Fermi 2 Power Plant
NRC Docket No. 50-341
NRC License No. NPF-43

Subject: Submittal of Revision 49 to the Fermi 2 Radiological Emergency Response
 Preparedness Plan

RERP Plan Revision 49 Change Analysis Summary

Figure B-5
EMERGENCY OPERATIONS FACILITY (typical)

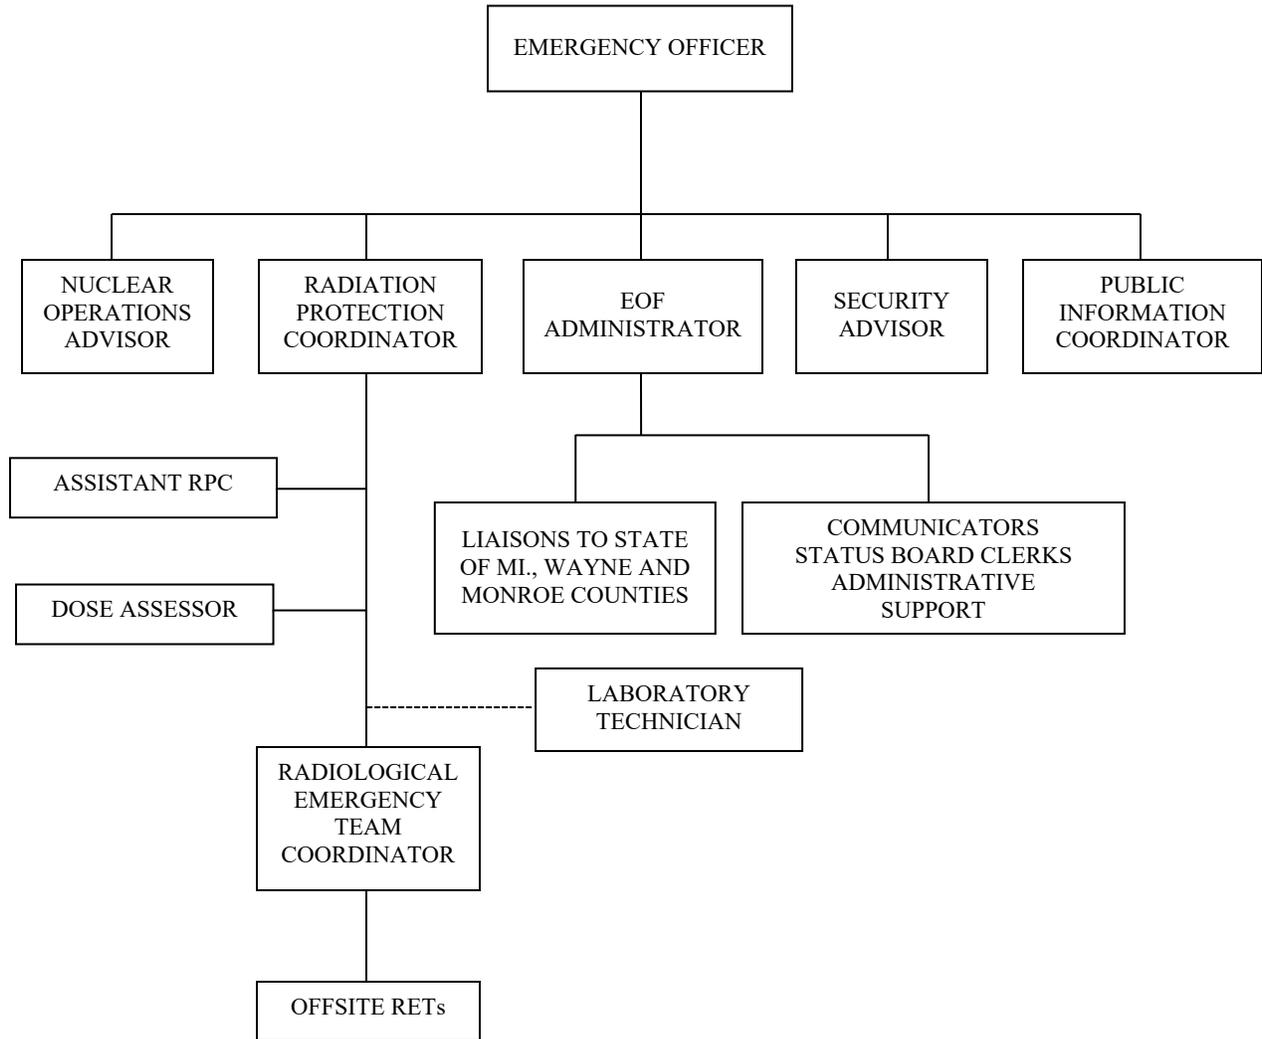
Figure B-5/B-8	Updated (typical) EOF figure to add Assistant Radiation Protection Coordinator.	The change is a correction to the EOF position chart. This position was not included previously but is normally staffed. The position is not part of minimum staffing as required by the RERP Plan nor the staffing analysis. It is a supplemental position that provides additional depth. Therefore, this change is not a reduction in effectiveness of the RERP Plan.

Section / Page	Change	Basis
Figure B-5/B-8	Simplified the “Laboratory Technician EOF Laboratory” title to the more generic “Laboratory Technician” title to account for variety in the person and reporting structure of whom may be assigned to perform offsite (or onsite) environmental (or other) sample analysis.	The change is editorial only. The position is staffed as needed from available Chemistry, Radiation Protection or other qualified staffing. The Laboratory Technician may perform the tasks at another count room or lab location on-site, such as the Availability Improvement Building (AIB) or Radiation Protection (RP) Count Room or Chemistry Lab, not necessarily the EOF Lab. The results would be reported to the requesting facility (i.e., TSC or EOF or both). Capabilities have not been changed nor impacted. Therefore, this change is not a reduction in effectiveness of the RERP Plan.
E.2/E-1, E-2	Editorial changes to rearrange order of information, step order, word simplification.	These changes were editorial in nature to improve clarity and step flow. Editorial changes do not detract from content. Therefore, this change is not a reduction in effectiveness of the RERP Plan.
